Serial: NPD-NRC-2008-067
December 26, 2008

**SHEARON HARRIS NUCLEAR POWER PLANT, UNITS 2 AND 3
DOCKET NOS. 52-022 AND 52-023
RESPONSE TO REQUEST FOR ADDITIONAL INFORMATION LETTER NO. 030 RELATED TO
BASIC GEOLOGIC AND SEISMIC INFORMATION**

**Shearon Harris Nuclear Power Plant Units 2 and 3
Response to NRC Request for Additional Information Letter No. 030 Related to SRP
Section 02.05.01 for the Combined License Application, dated October 14, 2008**

Location of the Deep River Basin
FIGURE 2.5.1-202 (Revised)

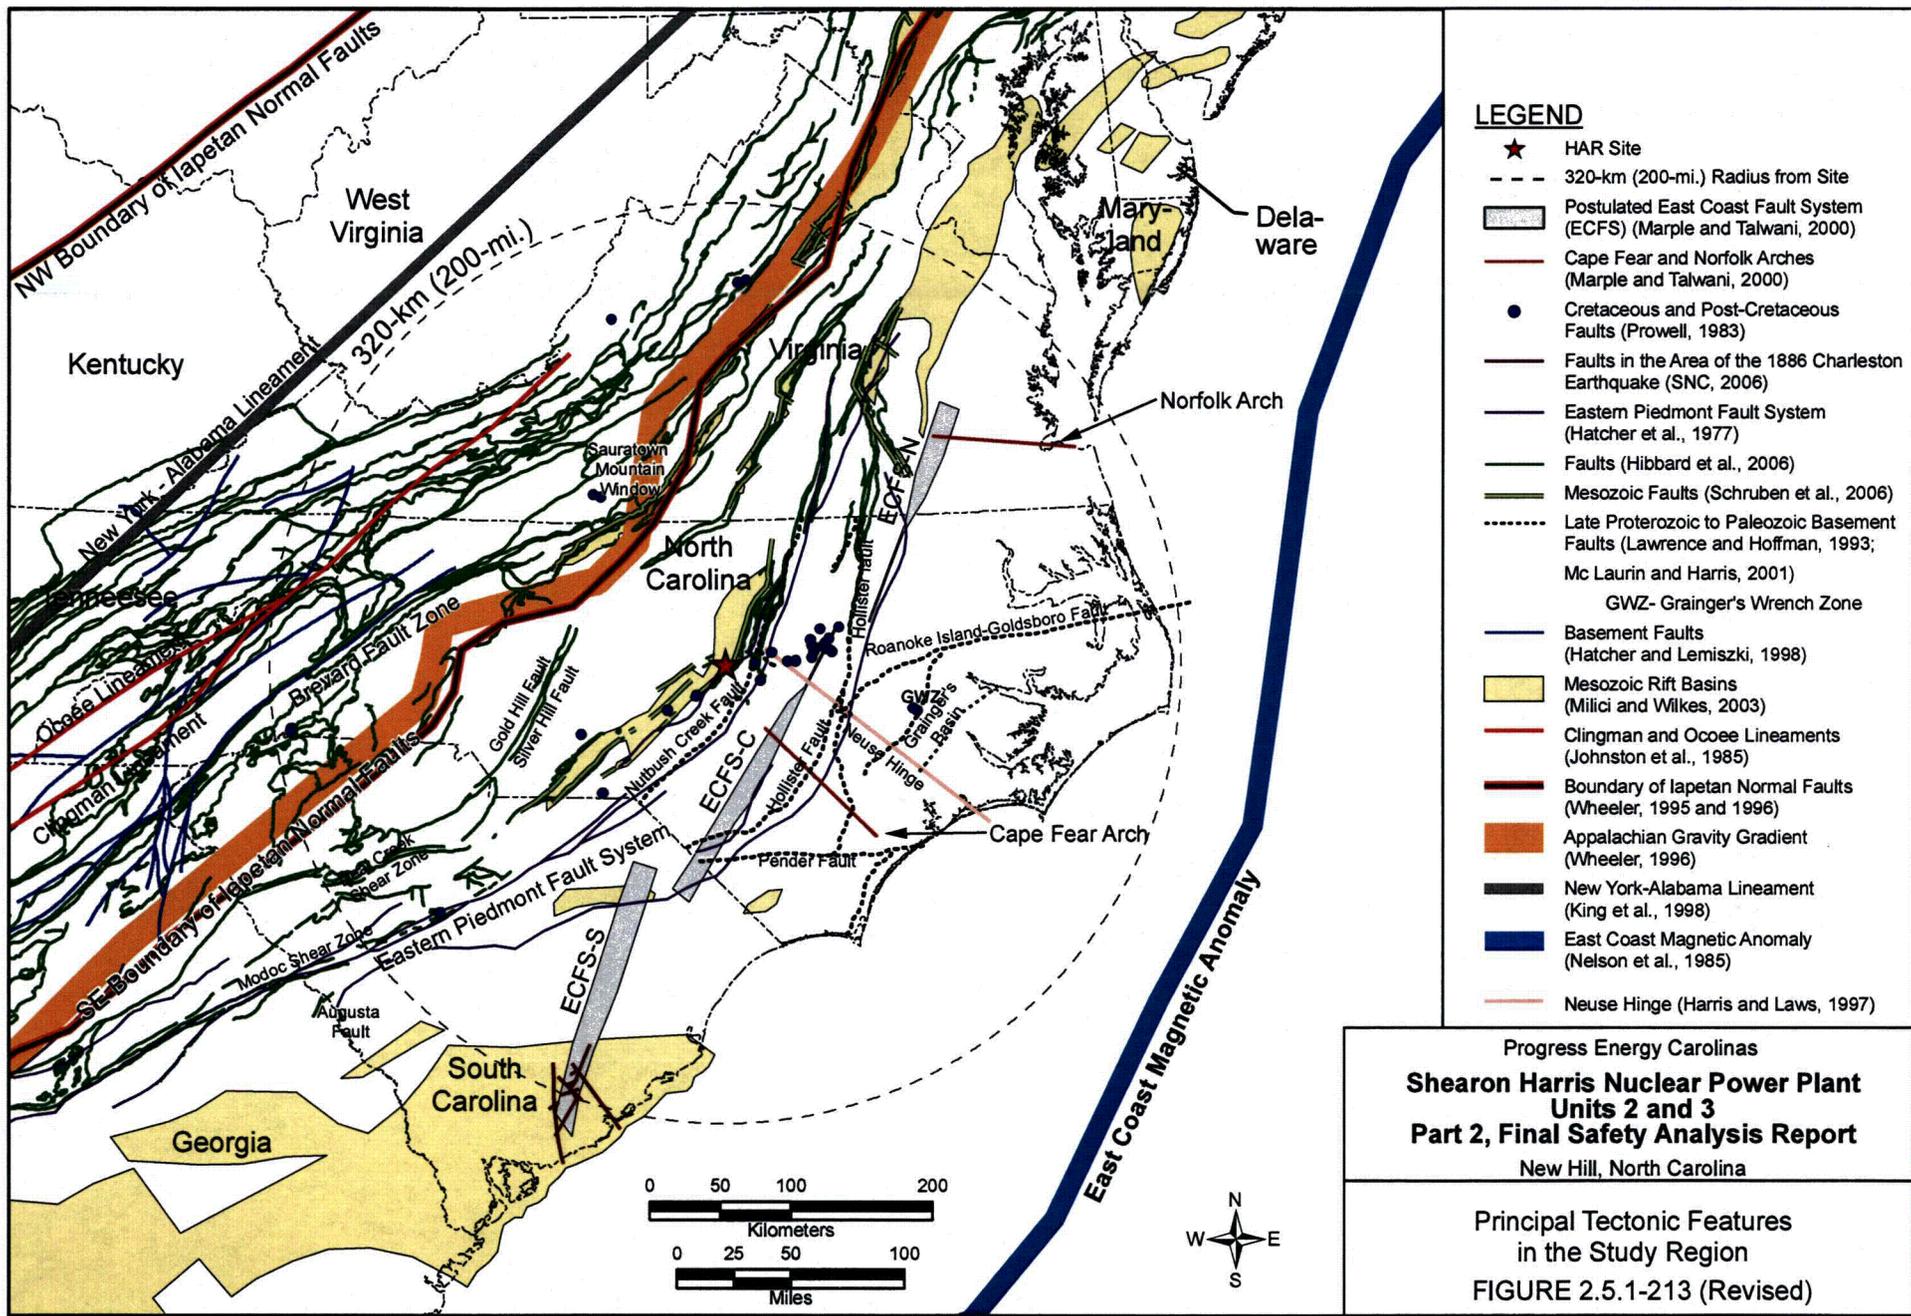
a) Figure 2.5.1-202 (p. 2.5-13) illustrates the rift basins in the region. The figure does not have labeling to indicate where the Deep River basin lies with respect to other basins that are labeled on the figure. In order for the staff to follow the discussion in text please provide additional labels to the figure.

a) Figure 2.5.1-202 will be modified in a future revision to only show the Deep River Basin. Additionally, the text states that "The Deep River basin is subdivided into three smaller basins named, from north to south, the Durham, Sanford, and Wadesboro basins" (p. 2.5-1 and 2.5-13). The sub-basins will be clearly shown on the revised Figure 2.5.1-202 Attachment 02.05.01-01A.

Central and Southern Appalachian
Tectonic Events
RAI 02.05.01-02 FIGURE 2

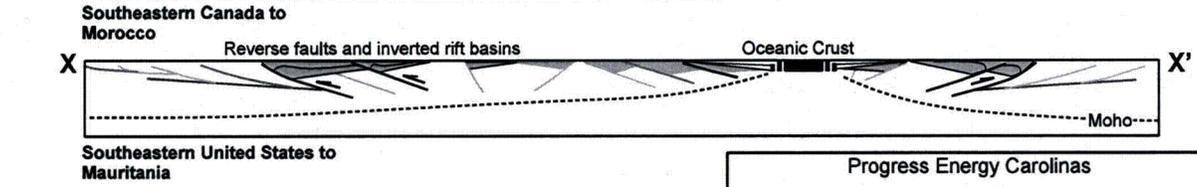
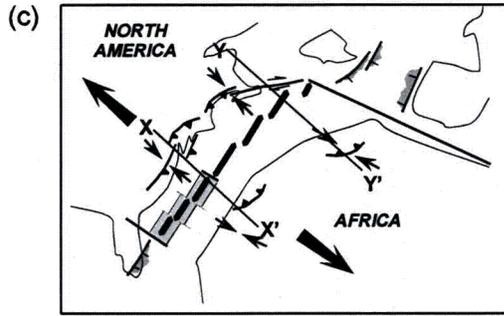
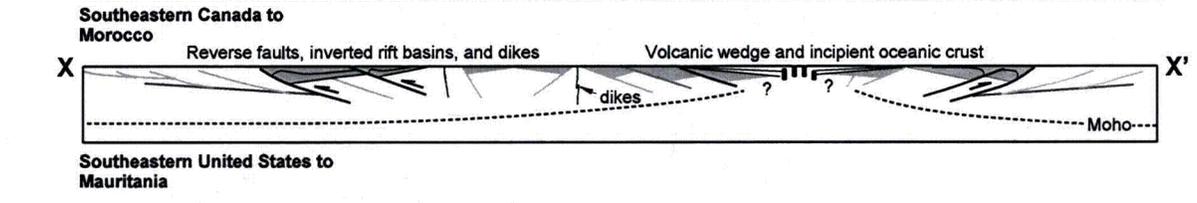
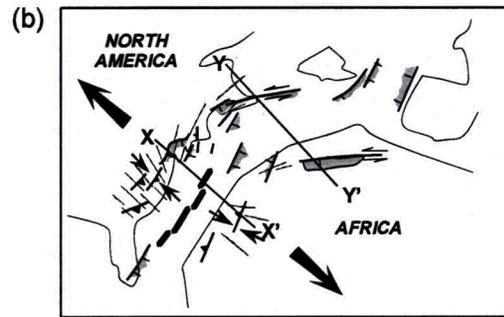
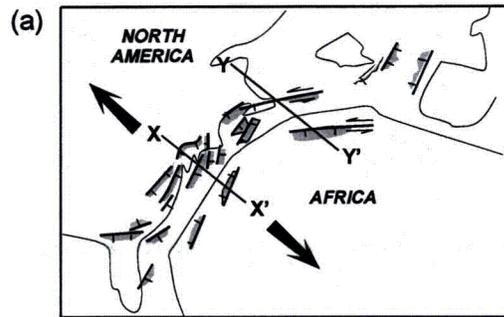
- c) Discussion in the texts repeatedly cites Figure 2.5.1-203 and 2.5.1-204. The figures do not correspond with each other with respect to labels used on each map. Please add terrane names from the map view to the column view so that NRC staff can connect the features in space and time, such as Carolina Magmatic arc and Laurentian rift and drift cover.

- c) FSAR Figure 2.5.1-203 will be deleted and replaced with a figure from Hatcher (RAI 02.05.01-02 Figure 2) (Attachment 02.05.01-02B) that is applicable to the entire Appalachians, not only to the central Appalachians. Text will be added to clarify the relationship of the age and timing of deformation recorded by the lithotectonic terranes in the region and a figure will be added to illustrate the tectonic evolution of the Southern and Central Appalachian Orogen (RAI 02.05.01-02 Figure 1) (Attachment 02.05.01-02A) to help clarify the timing of events in the site region.

Sketches Showing Evolution of
 Central Eastern North America
 during the Mesozoic
FIGURE 2.5.1-206 (Revised)

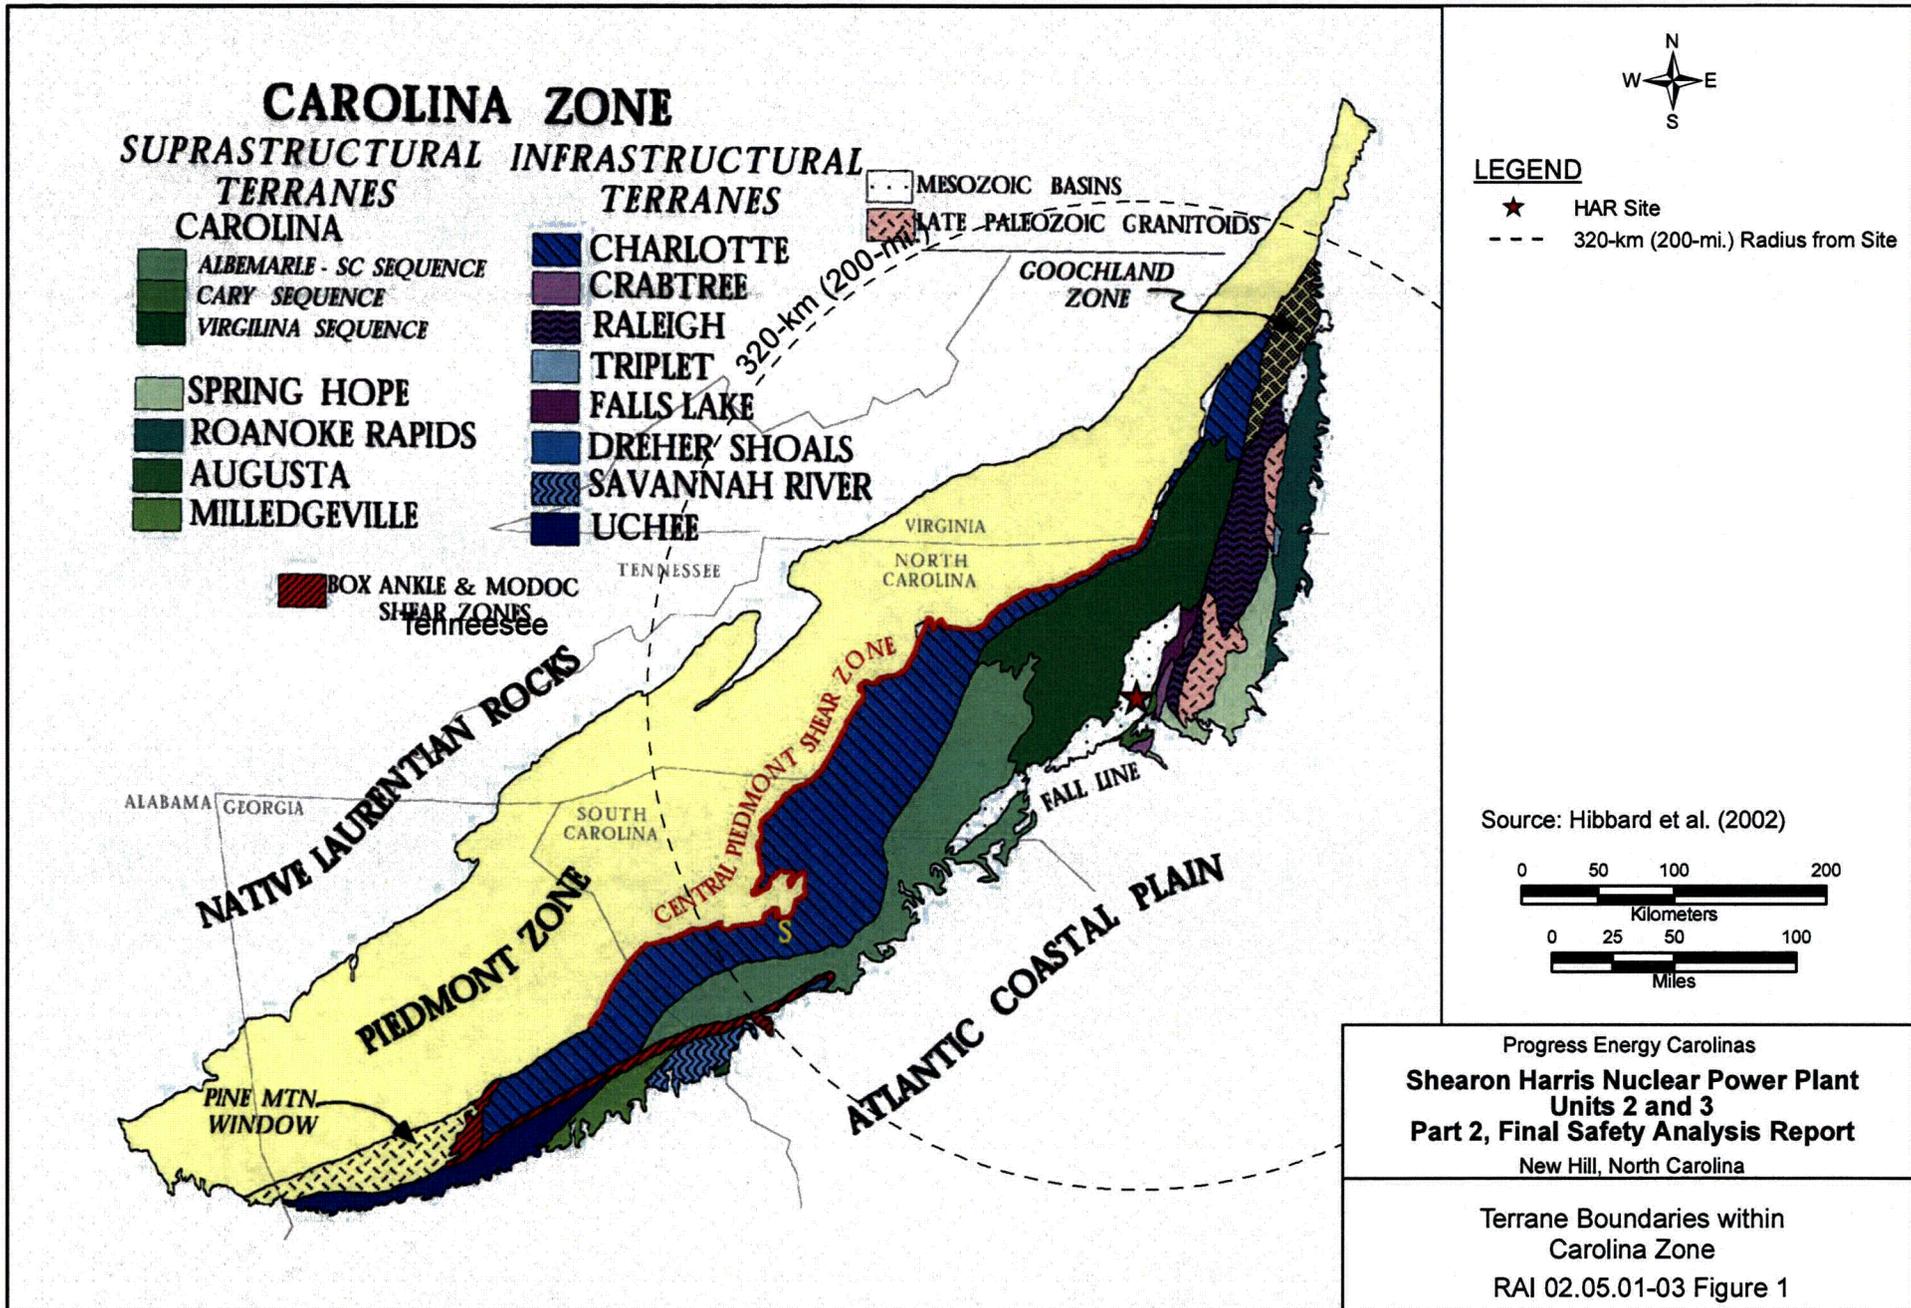
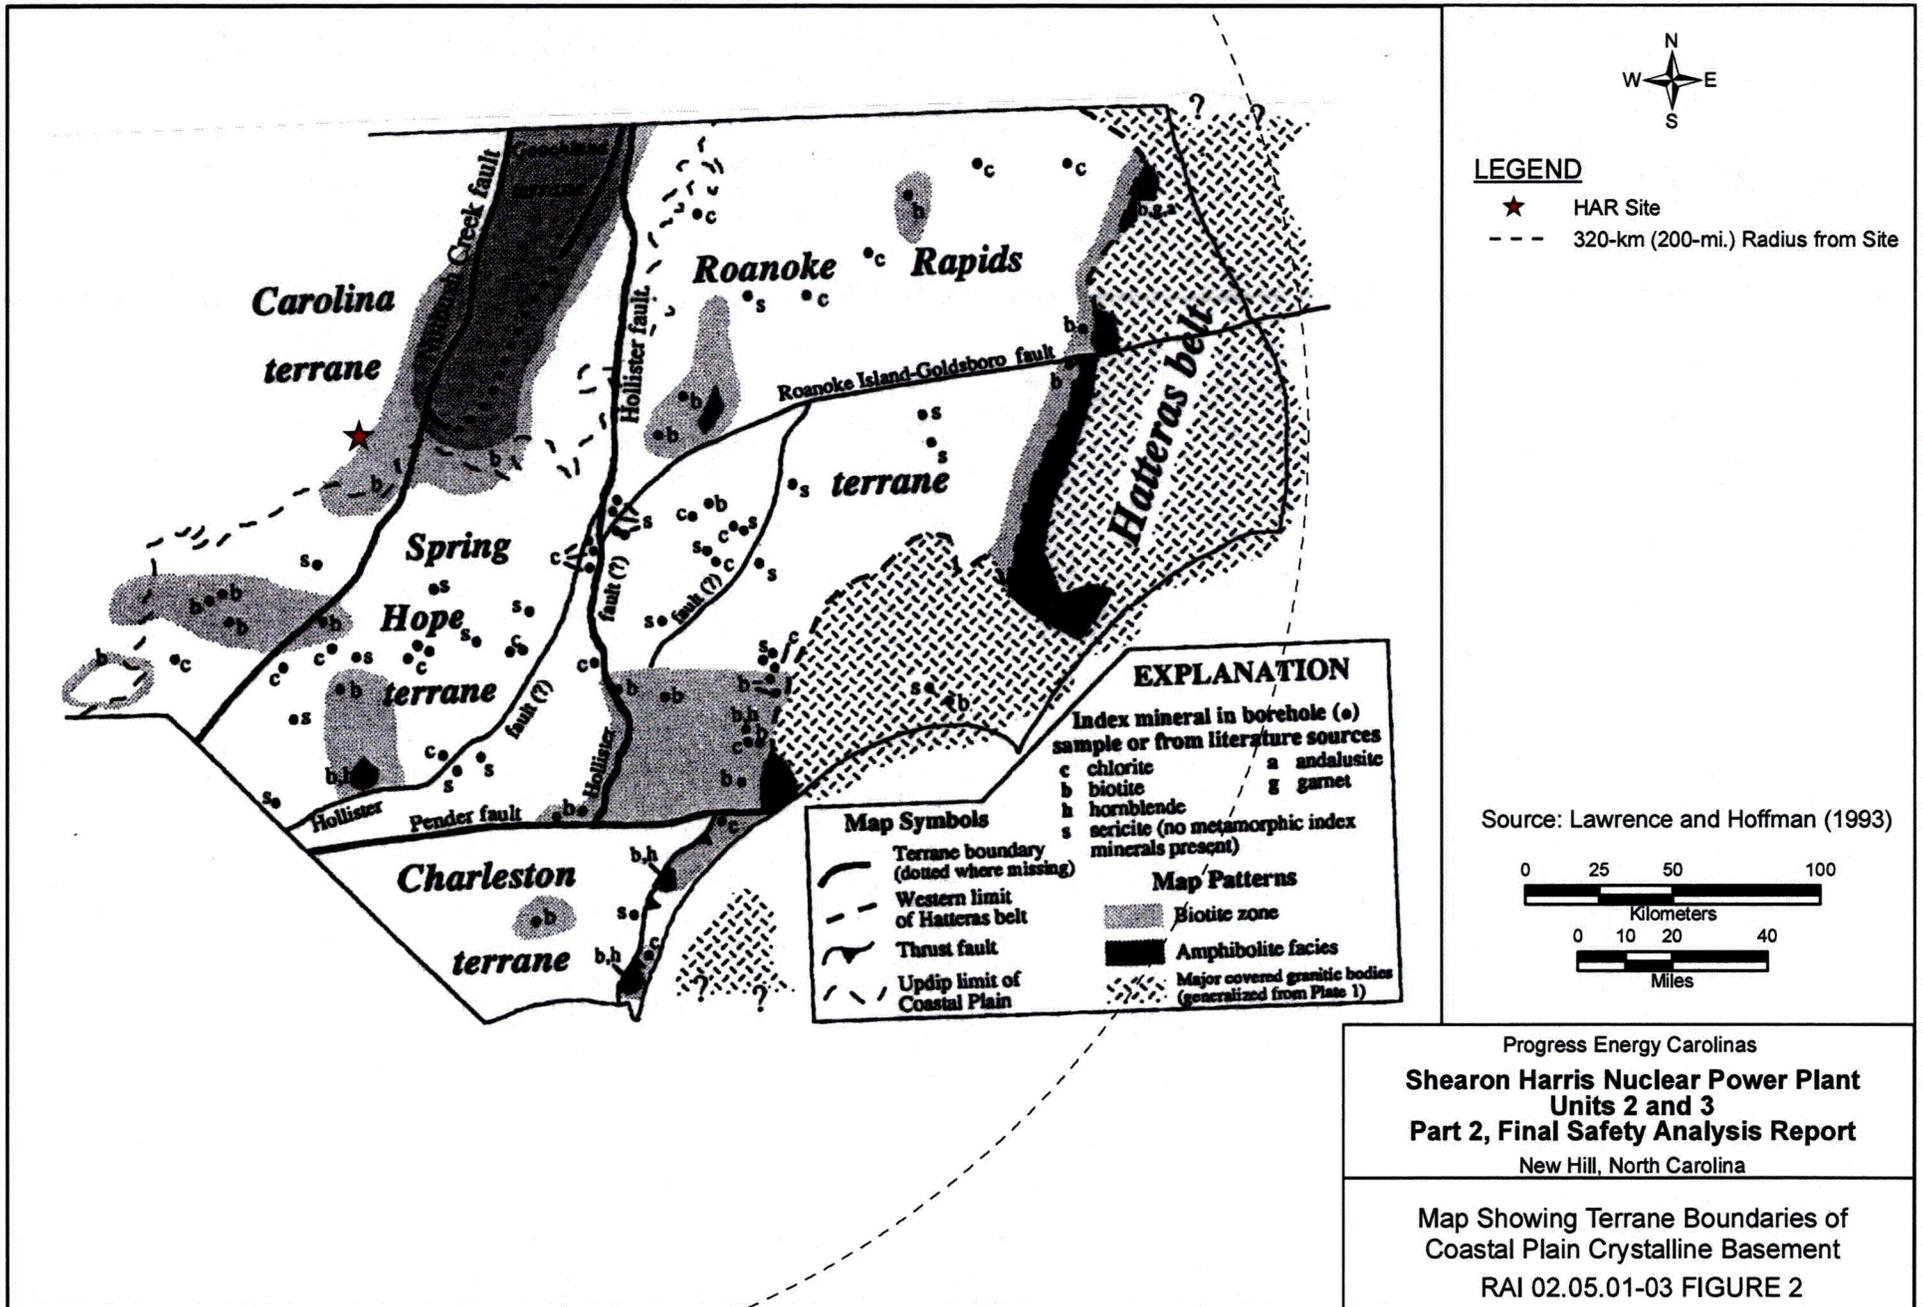
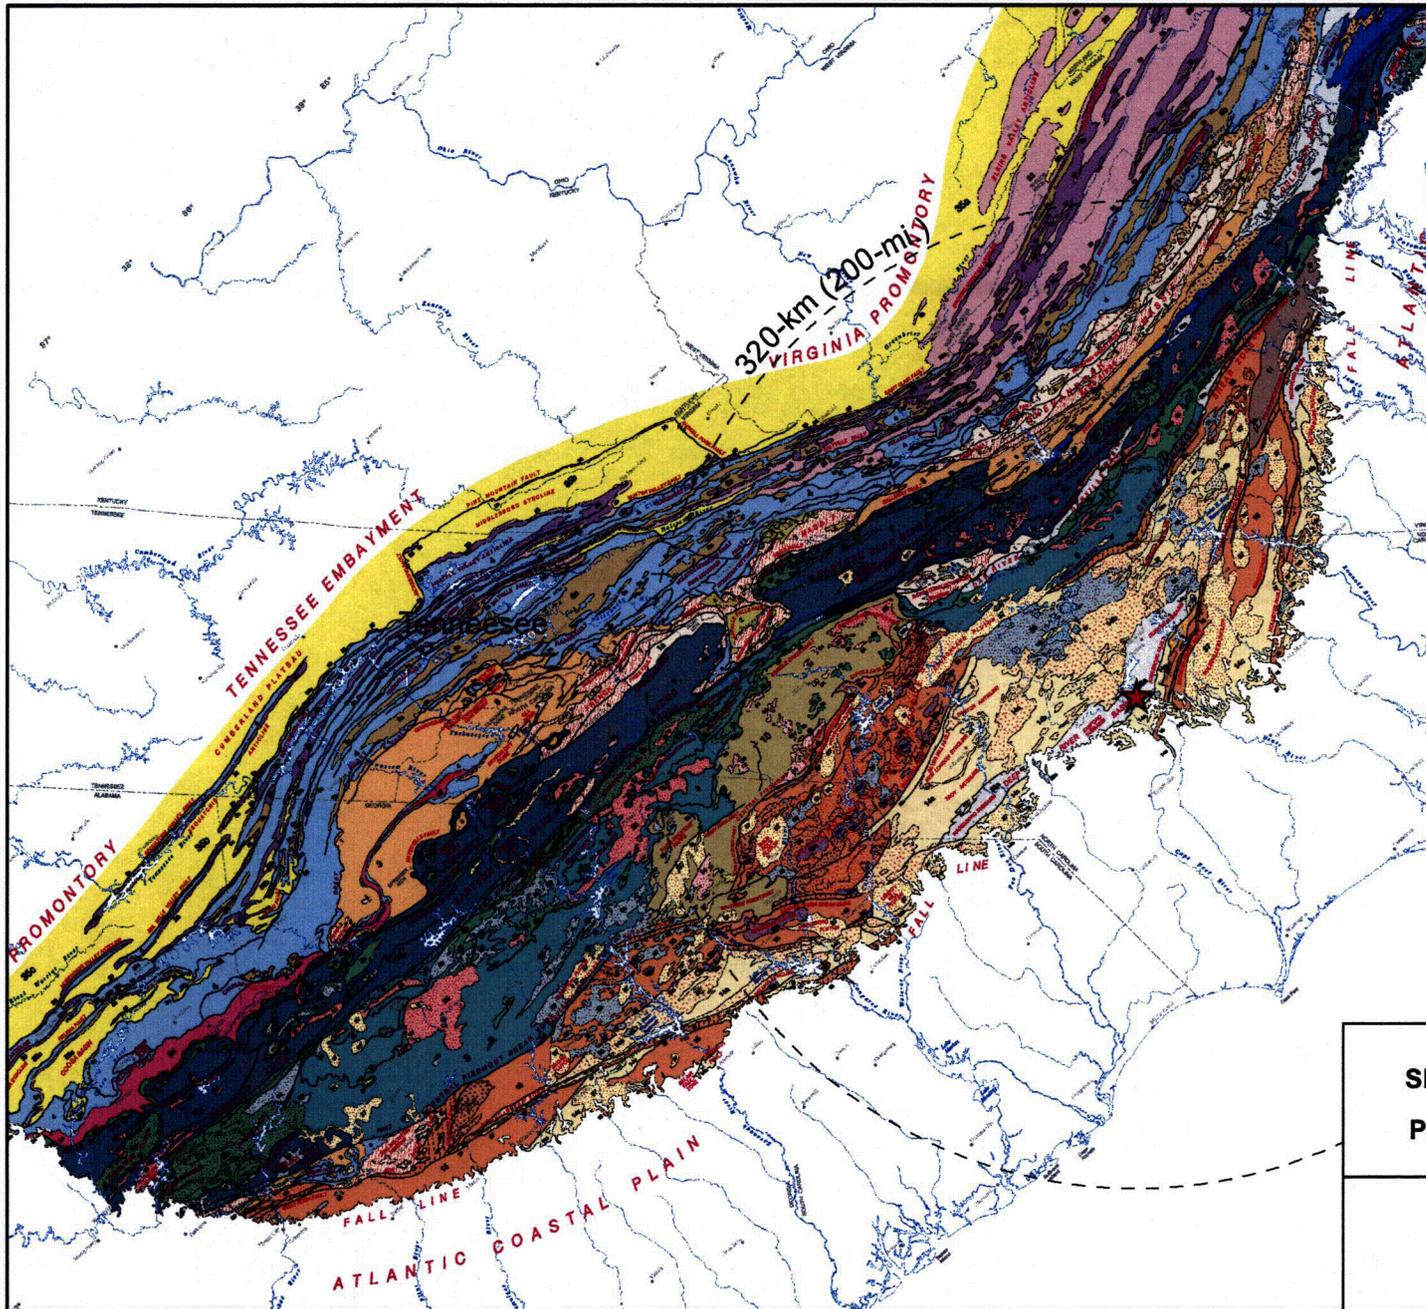
- d) FSAR Section 2.5.1.1.2.2 cites Figure 2.5.1-206. The 5 cross-sections sections are not located on the map views of the same figure. Illustrate how the 5 x-sections on this figure fall out onto the 3 map views on the same figure.

- d) FSAR Figure 2.5.1-206 is taken directly from Withjack et al. (Reference 2.5.1-219). The general locations of the cross sections are explained in the figure caption as either going

from Southeastern Canada to Morocco (X-X') or from Southeastern United States to Mauritania (Y-Y'). Approximate locations of the cross sections and links to the stages of development (b and c map insets) will be added to revised Figure 2.5.1-206 for clarification in a future revision.
